# Consultants Final Lot Grading Certification Letter

**Re:      Municipal Address:**      1348 Harrington Street  
**Lot or Block No.:**      Lot 64  
**Registered Plan No.:**      2021-0381  
**Certification of building and final lot grading**  
**Bellaire Properties Inc.**

1348 HARRINGTON STREET  
LOT 64, PLAN 51M-1088  
PHASE 2, STAGE  
BELLAIRE PROPERTIES INC.  
PARCEL P1 - LEFROY  
TOWN OF INNISFIL

DRAWING No:  
**A-1**

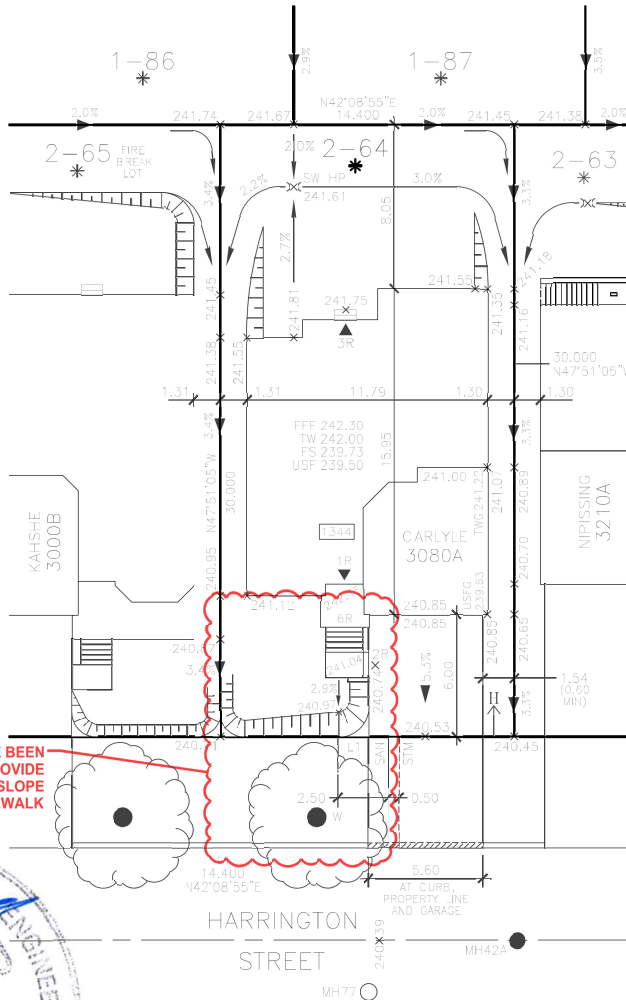
APPEARS TO HAVE BEEN  
CONSTRUCTED TO PROVIDE  
A MORE GRADUAL SLOPE  
FROM HOUSE TO SIDEWALK
